30/13-00B 4710 Waverly Avenue  
(Garrett Park Historic)

## Changes to Plans for

4710 Waverly Avenue, Garrett Park, MD, 20896-0424

Permit Number: 232765

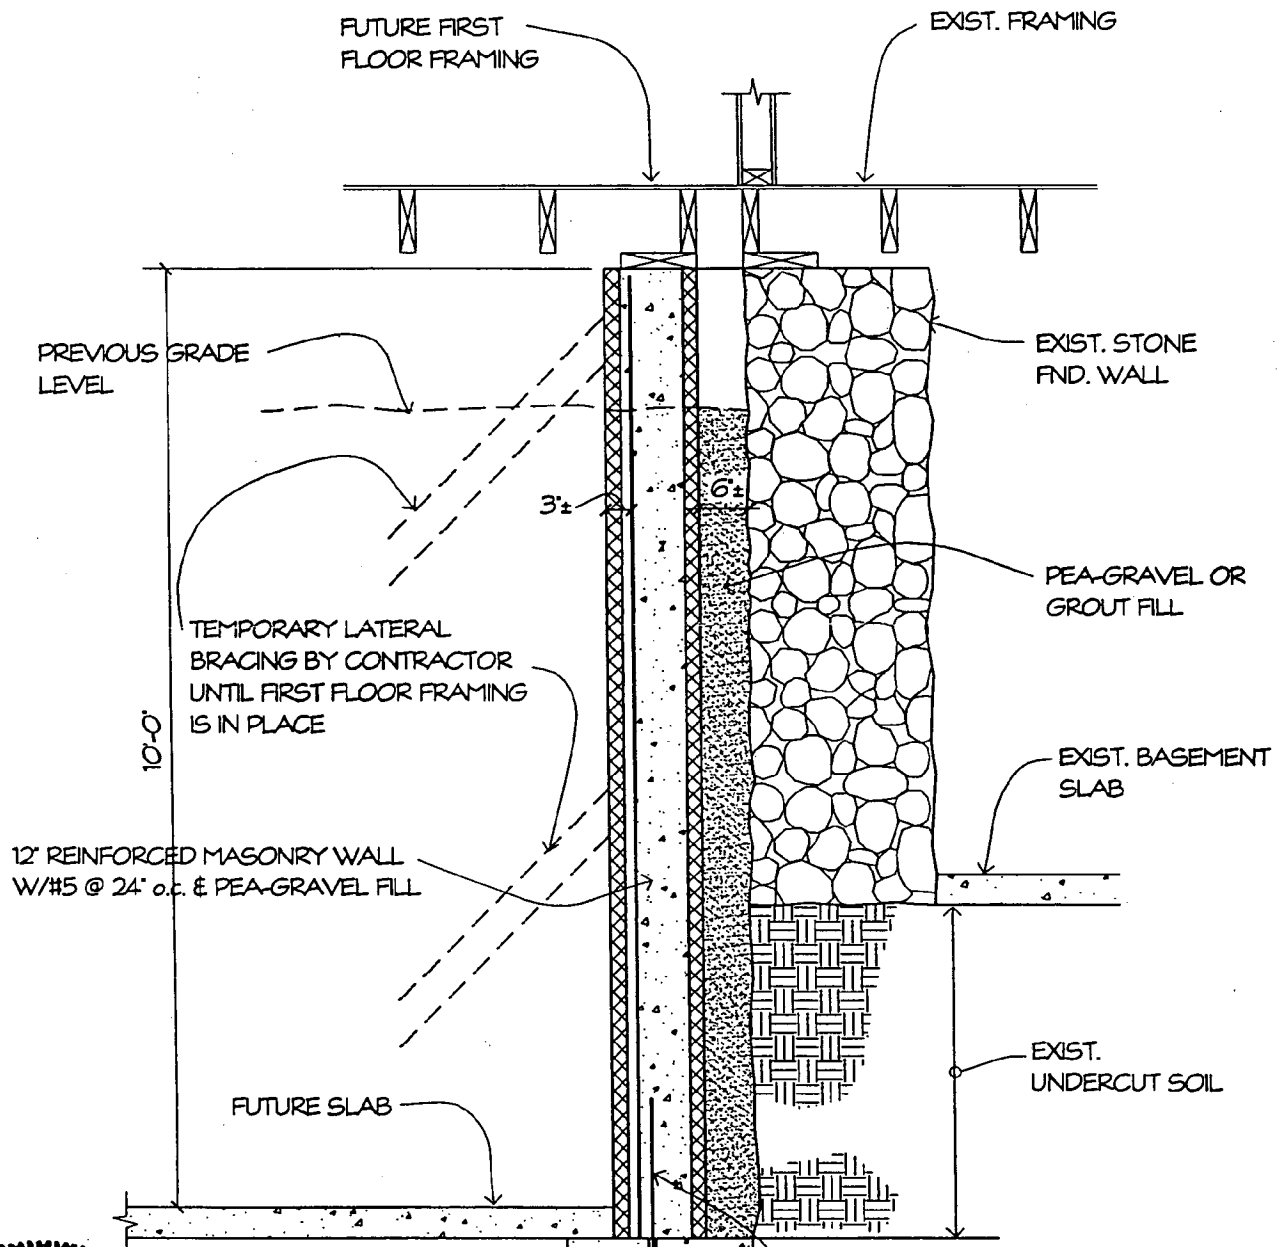
As I say, the Commission approved my preliminary drawing which included an interior connecting passage way. On the copy of Circle 11 attached, note the new 6'7" wall (highlighted in yellow).

I am requesting permission for the approved architect's drawing to be modified to re-instate the connecting passage, and to allow the double entry doors from the porch to be in this 6'7" wall. This small area will serve as a small entrance hall as well as provide passage between the old and the new parts of the house.

**DETAIL OF NEW BASEMENT WALL  
AT UNDERCUT STONE FOUNDATION**

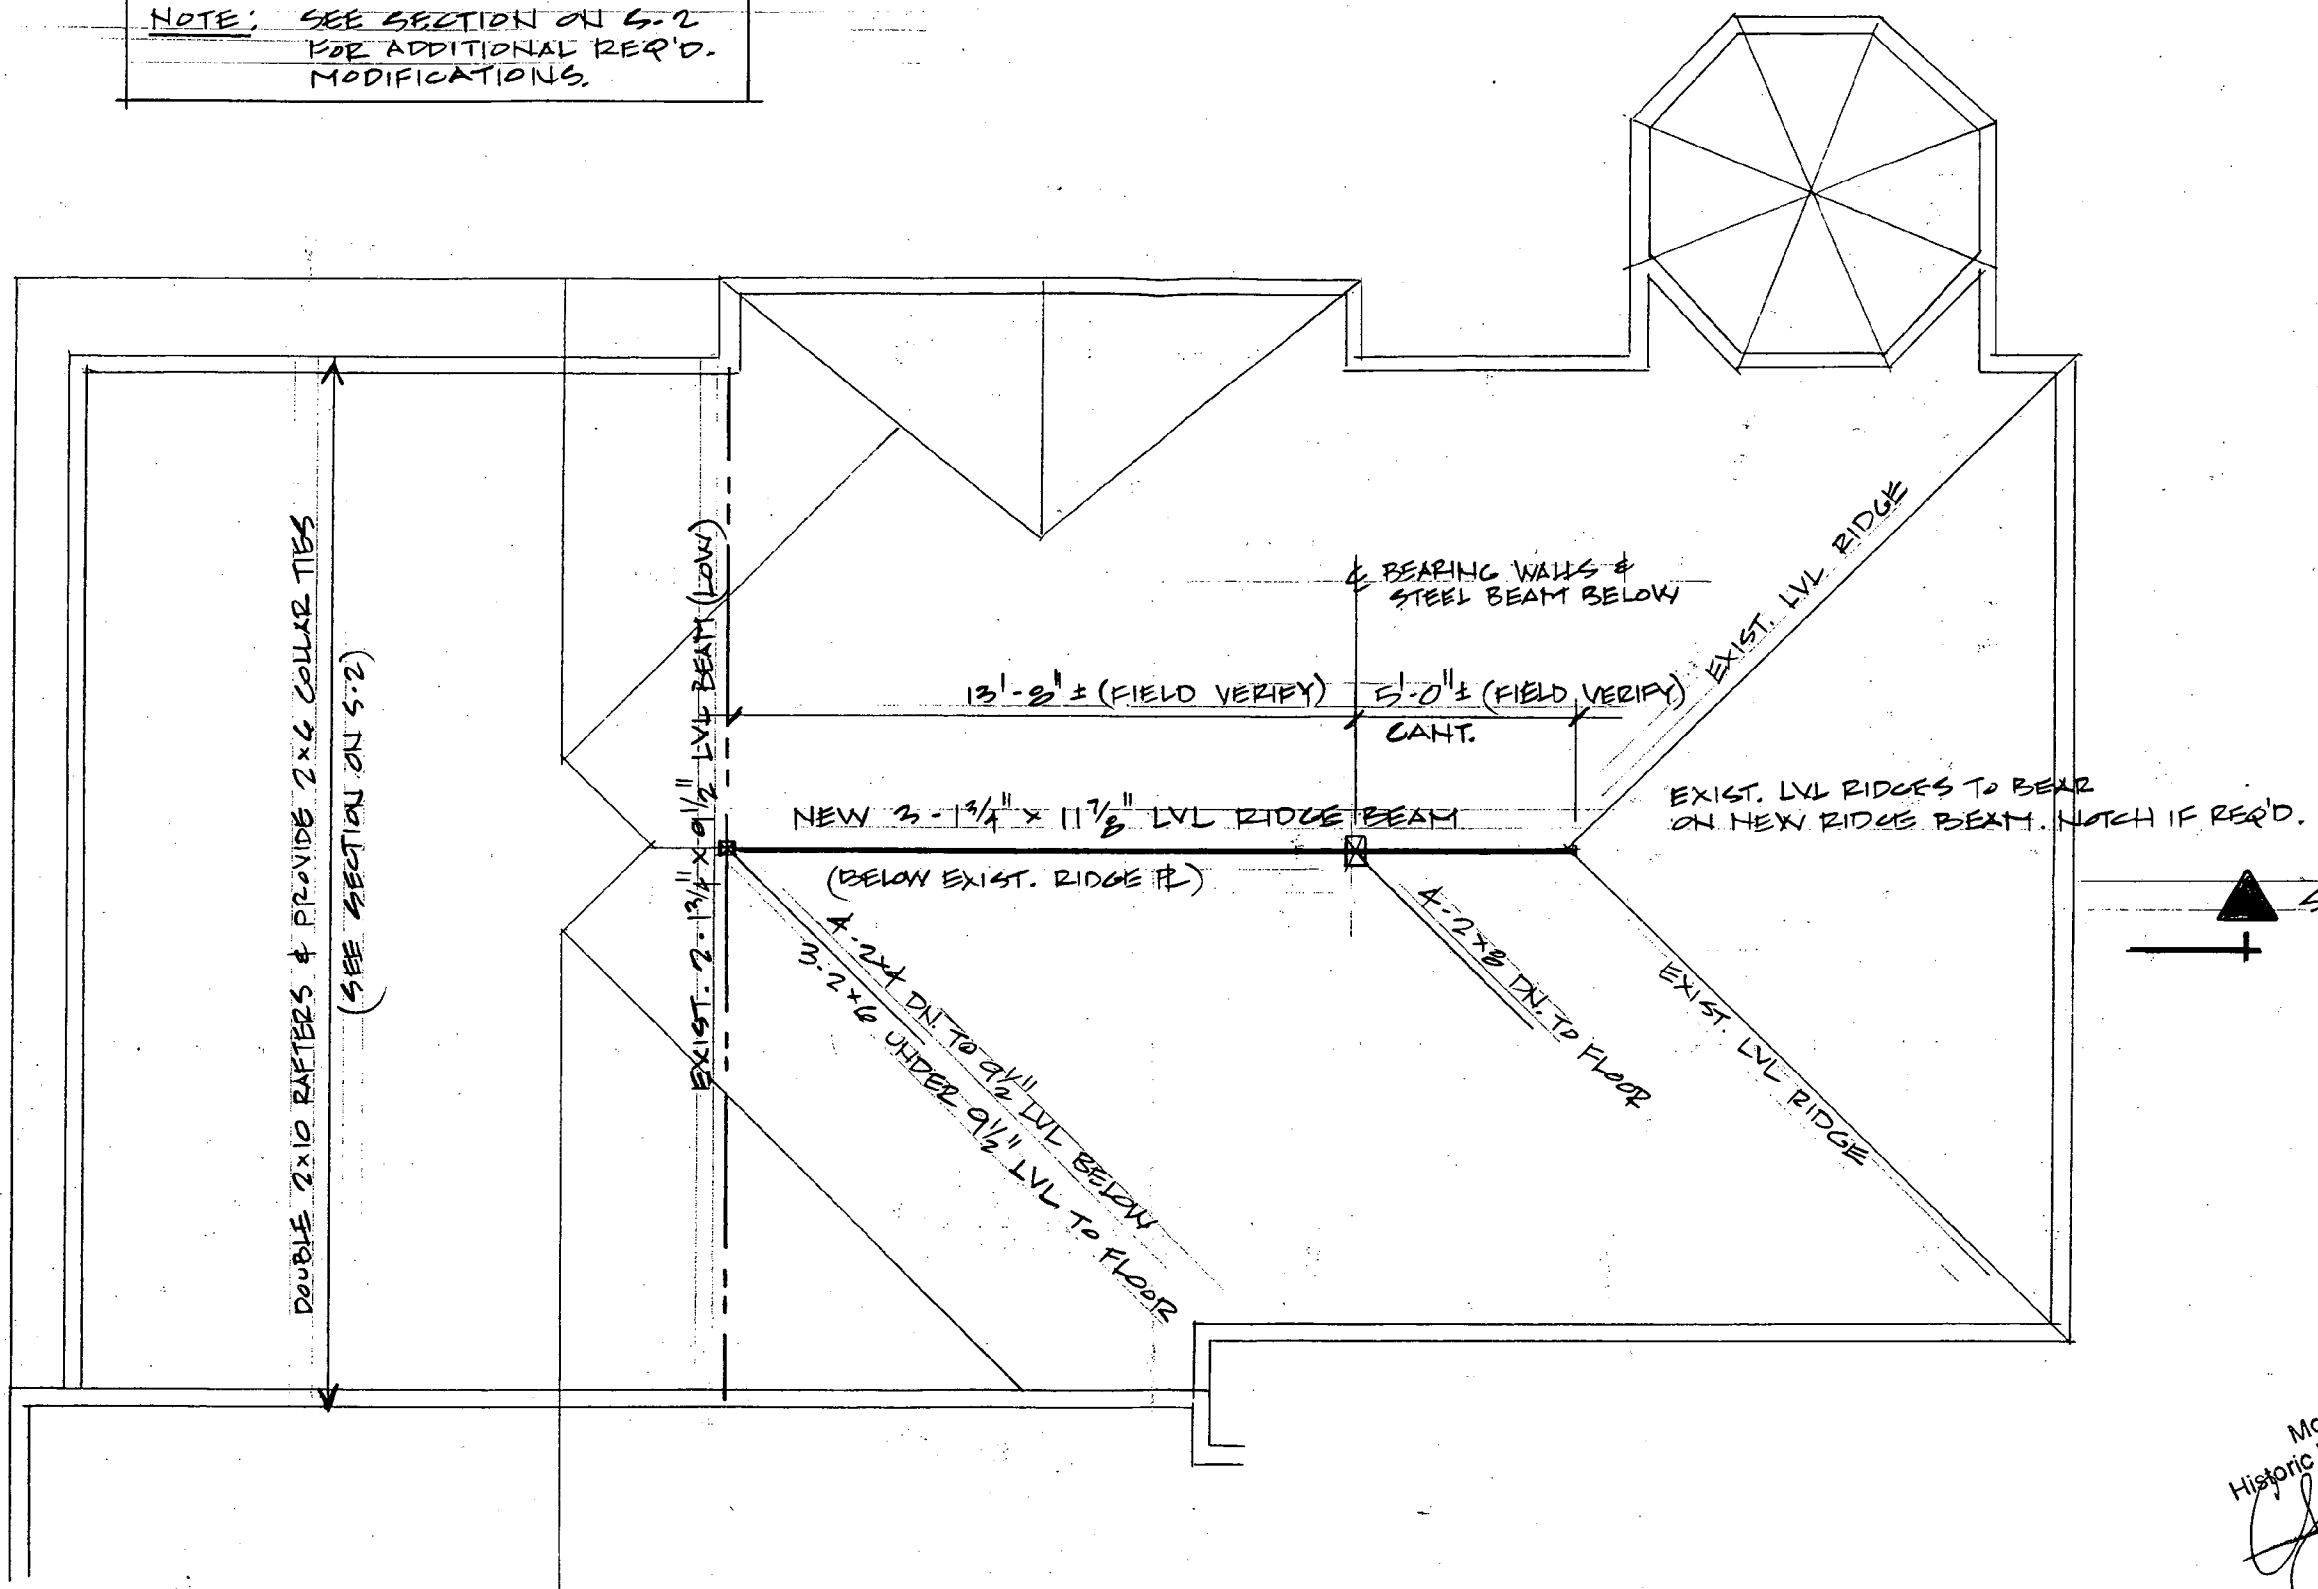
1. **Drawing 1. Basement Plan:** Bulldozer inadvertently removed dirt from portion of area to be left remaining. Structural engineer Jolles & McKenzie visited the site and established a revised structural plan for footings adjoining existing house (drawing dated March 16, 2001). See also Drawing 6 label F.

**PLAN - ROOF FRAMING MODIFICATIONS**

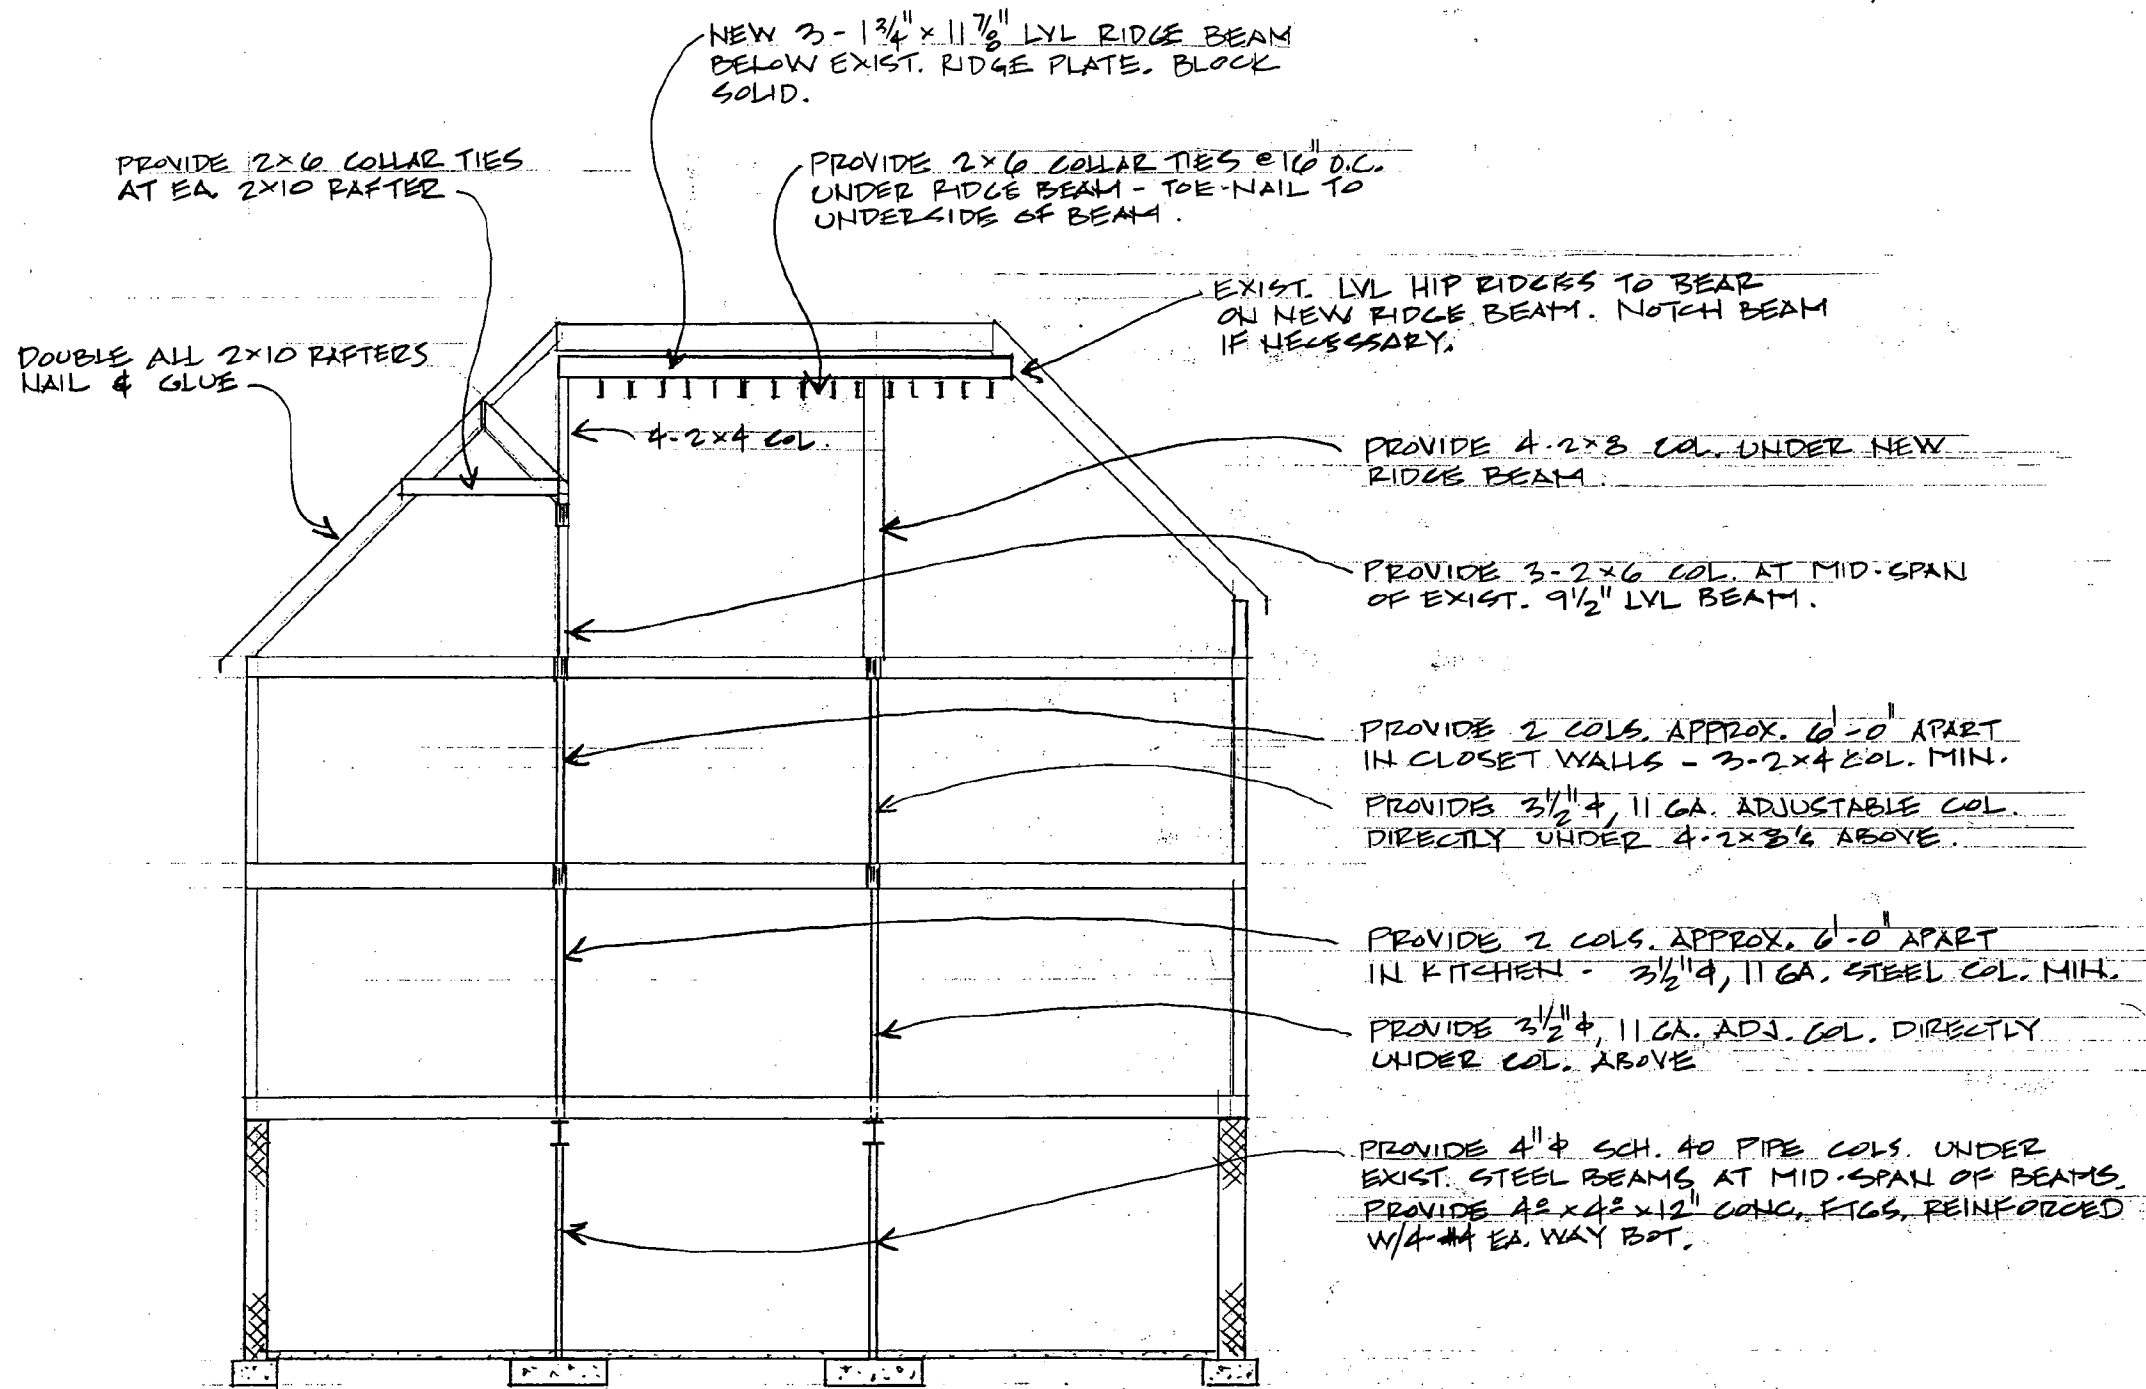
4. **Drawing 2. First Floor Plan:** Moved bathroom to pantry area (left side of first floor plan).
5. **Drawings 6, 7 and 7a. Structure, Third Floor and Roofing Plans:** The architect's roof plan was incorrect. The ridge plate should not have been used with the knee wall, which began to move. The structural engineer from Jolles and McKenzie visited the site and established revised structural plan for a supported roof beam with supports down to the footings in the basement floor (drawing dated January 4, 2002).
